# UNITED STATES PATENT AND TRADEMARK OFFICE

10/705,899

**Office Action Summary**

## DETAILED ACTION

FIG. 4

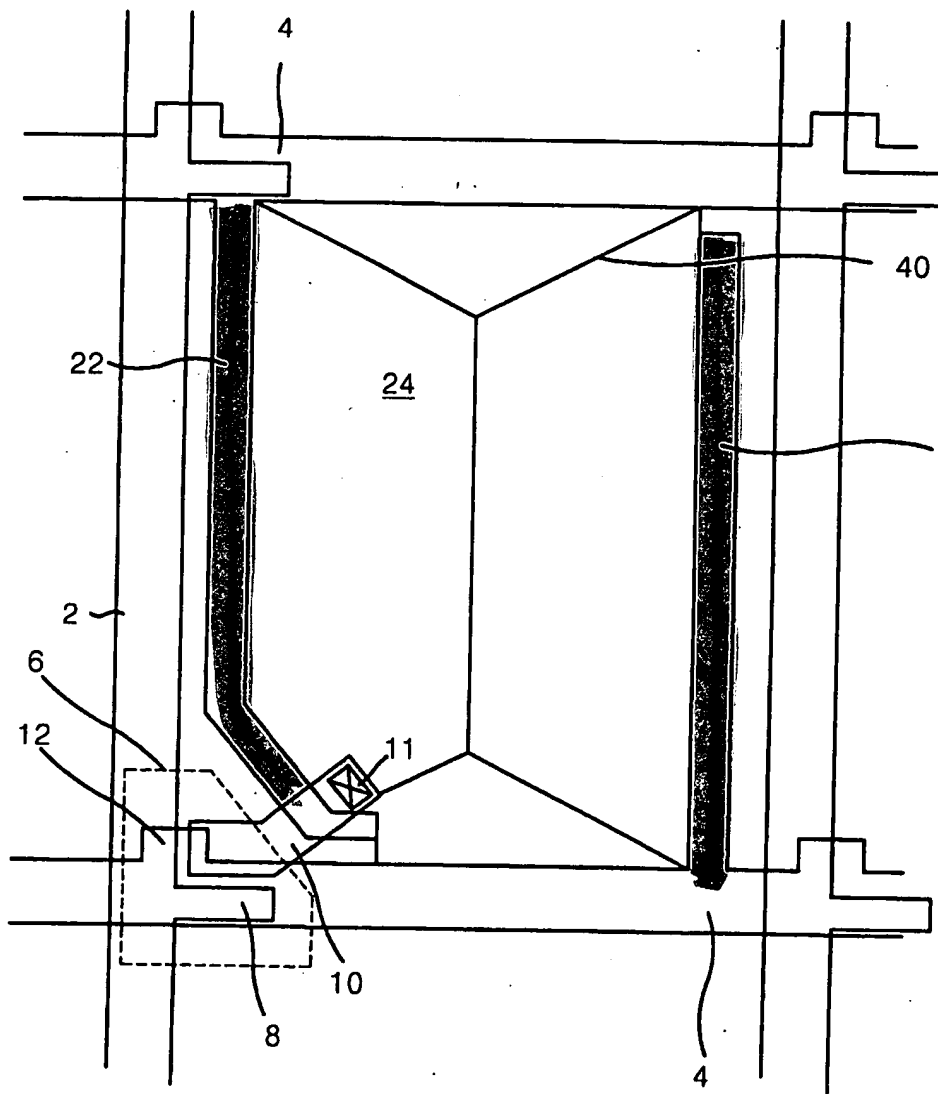
Fig. 4 shows that the auxiliary electrode line (extending from and connecting with gate lines) is formed between the pixel electrode and the data line at an outside of the pixel electrode in the pixel region and the auxiliary electrode 22 is not overlapped with the pixel electrode 24, but also not overlapped with the data line (see attachment).

auxiliary  
electrode is  
not overlapped  
with pixel  
electrode 24
